Technical Service Bulletin

NUMBER: 24-20-99 Rev. A

SUBJECT:

While In Bi-level Mode, Air Flow From Panel Vents Is Less Than That Of The Floor Vents

FIGURE 14

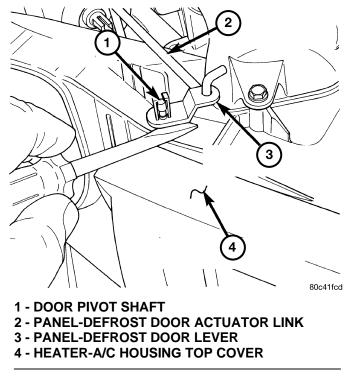
43. Using a trim stick, gently pry the panel-defrost door lever off the panel-defrost door pivot shaft (Figure 14).

44. Slide the panel-defrost door lever off from the panel-defrost door actuator link.

- 45. Slide the new panel-defrost door lever, p/n 03847858, onto the panel-defrost door actuator link.
- 46. Snap the panel-defrost door lever onto the panel-defrost door pivot shaft.
- 47. **Slide push nut p/n 06031147 over the end of the actuator link until the push nut is tight against the panel-defrost door actuator lever (Figure 15).**
